Access Compliance Report Public Rights-of-Way (Curb Ramps)

Main Street: HOWLAND_WAY Cross Street: ARBOLADA_WAY Location: SW

ADA ID: RPAT211004151843 Ramp Type: Type 1 - Perpendicular Diagonal Initial Pass/Fail: Fail Overall Compliance: No Severity Score: 2

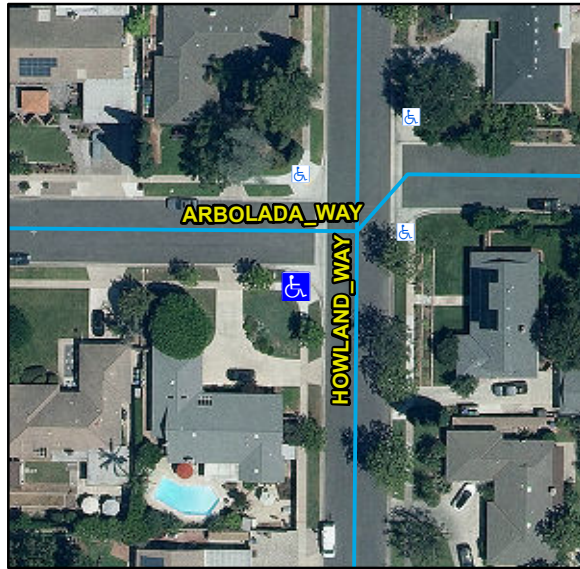
R304.2.2, R304.5.3, STD 1115

Remove & Replace Curb Ramp With Two New Directional Ramps or Equivalent.
